Final Decision

Planning Commission

File number(s): MC 2020-02 Related to DR 2019-05 & EXCP 2020-05

Project name: Allison Way Apartments: Condition EX2 Stacy Allison Way Improvements

Exhibit EX2b revised June 2 (Median example concept not to scale.)

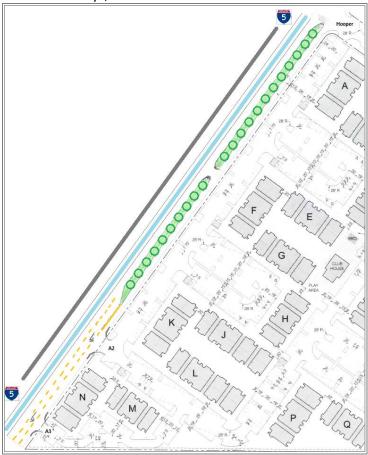
MOC 2020-02 Final Decision Attachment C 2. Revising Street Exception Condition EX2 to omit a landscaped median from the required custom cross section of the Stacy Allison Way extension to maintain a continuous two-way left turn lane along and between Interstate 5 and the approximately 800 ft of site development frontage that has no driveways; and
